PLANNING UNIT REPORT DEPARTMENT OF PLANNING AND DEVELOPMENT of May 9, 2006

RE: LD. # 03487, Conditional Use Application - 5702 Raymond Road

- 1. Requested Action: Approval of a major alteration to an existing shopping center in excess of 25,000 square feet with a drive-up window to allow construction of an addition to the shopping center with a drive-up window for a new drugstore, all generally located 5702 Raymond Road. The site is also a planned commercial site.
- 2. Applicable Regulations: Section 28.09 (2)(d) identifies drive-in/ up establishments and zoning lots with greater than 25,000 square feet of retail as conditional uses in C2 zoning. Section 28.12 (11) provides the guidelines and regulations for the approval of conditional uses. Section 28.04 (24) provides the guidelines for planned commercial sites. Section 33.02 (f) provides the standards for large retail establishments, which the center is considered.
- 3. Report Prepared By: Timothy M. Parks, Planner

Exhibit page "A0.1 Site Plan" [3/22/2006], notated with approximate amenity location

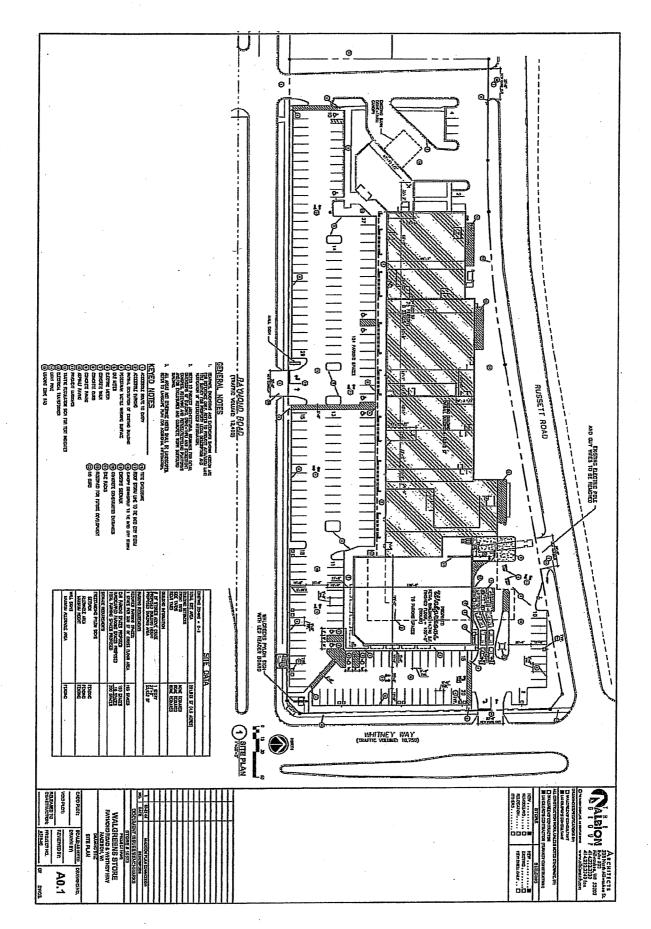
- 1. The applicant shall install a concrete passenger boarding pad on the north side of Raymond Road, approximately 100 feet west of Whitney Way, within the area of the driveway apron proposed to be abandoned. The concrete pad shall occupy the full distance of the terrace, measure 6 feet in width parallel to the street, and lie flush between the sidewalk and the top of curb.

- 2. The applicant shall install and maintain a bench or other seating amenity and a trash receptacle on top of a concrete pad or other suitable surface on the north side of Whitney Way west of Whitney Way, in an area adjacent the concrete passenger boarding pad described above. If installed on City right-of-way between the curb and sidewalk, the amenities may not obstruct a six-foot zone of concrete pad between the curb and sidewalk on the west end, furthest from the intersection.
